LOUISIANA / 142 DELARONDE STREET POWER & LIGHT / PO BOX 6008 • NEW ORLEANS, LOUISIANA 70174 • (504) 366-2345

April 24, 1982

SUBJECT: Waterford 3 SES Emergency Plan

The Waterford 3 SES Emergency Plan Figure 7-11 will be revised as follows:

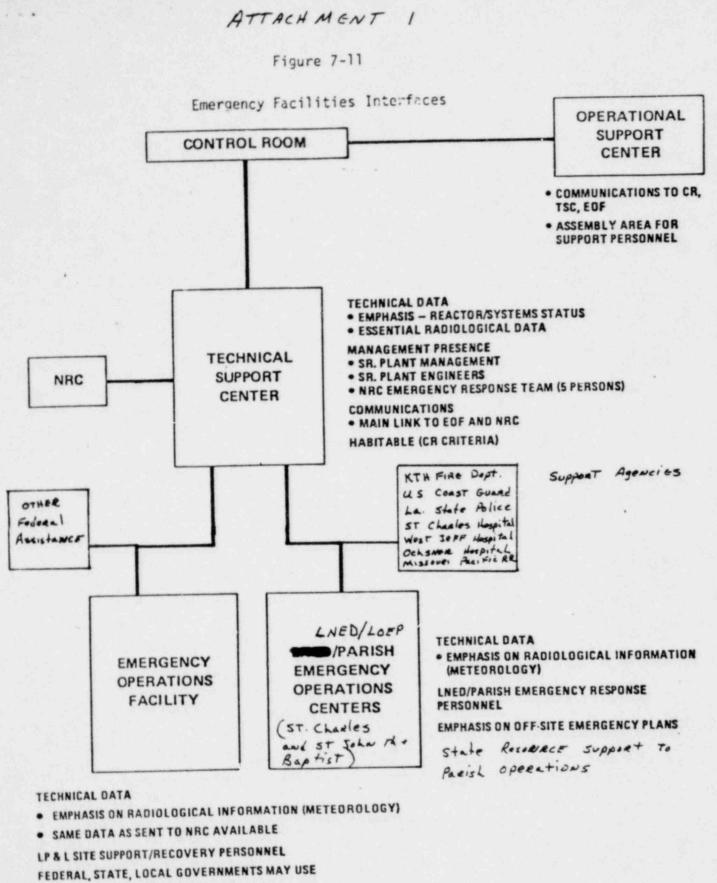
## See Attachment 1
